Conveyor package - Queries & replies - 4x270MW, Bhadradi project.

| JOB No. | 411 | BHEL Doc. No: PE-DC-411-161-A001 | | | Rev: 01 |
| TITLE | | BUNKER SIZING CALCULATION | | | |

| Project name: Bharat Heavy Electricals Limited 4x270 MW BHADRADRI TPS | | | | | | |

| TITLE | | COAL BUNKER PROFILE | |

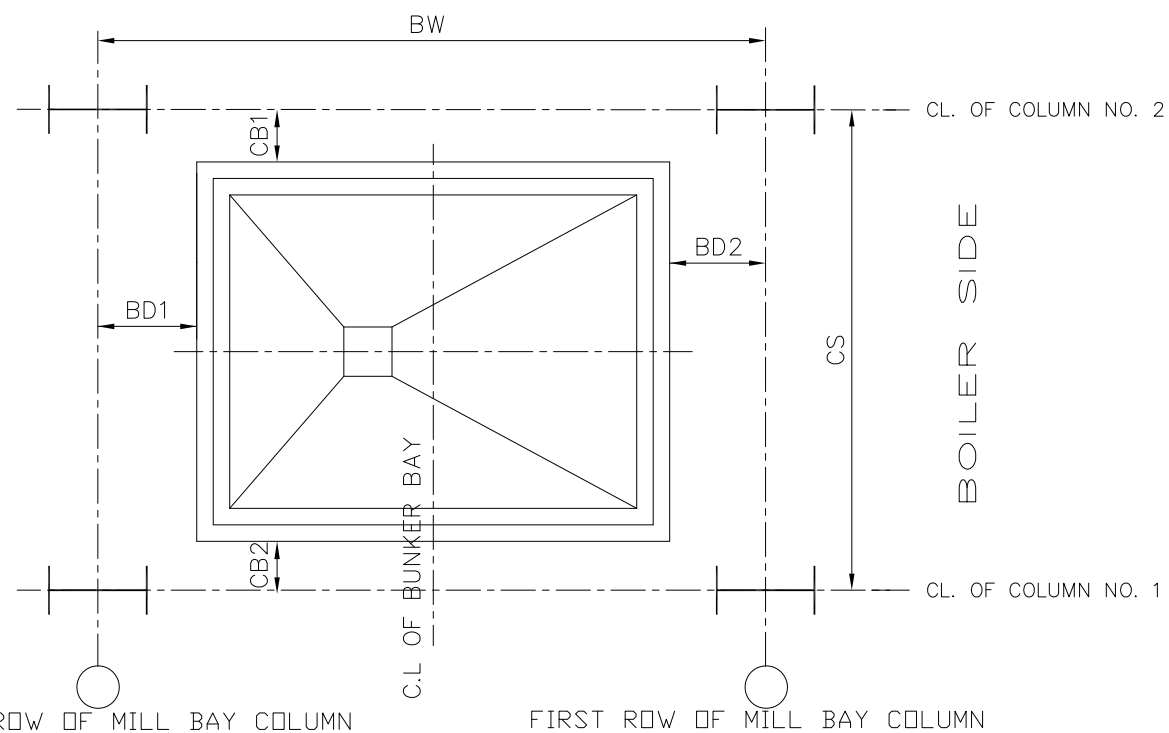
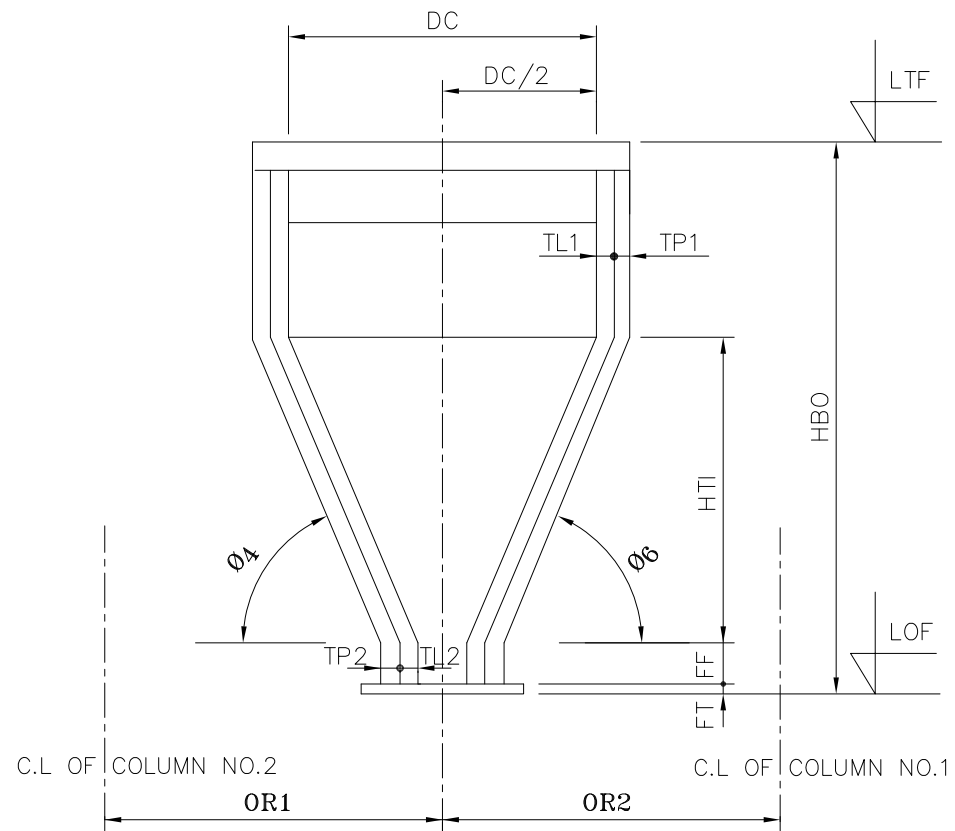
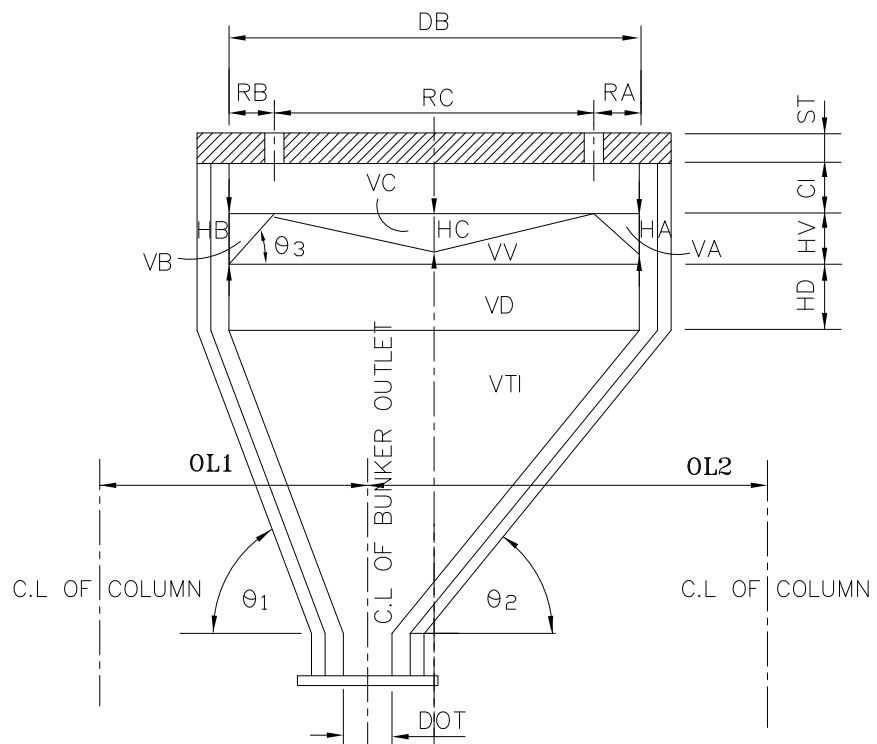
| S.No. | Reference Clause | Bidder's Queries | BHEL Replies, Dtd: 04/06/15 |
|-------|---|---|--|
| 5 | | - | Bunker sizing calculation is enclosed for your reference. |
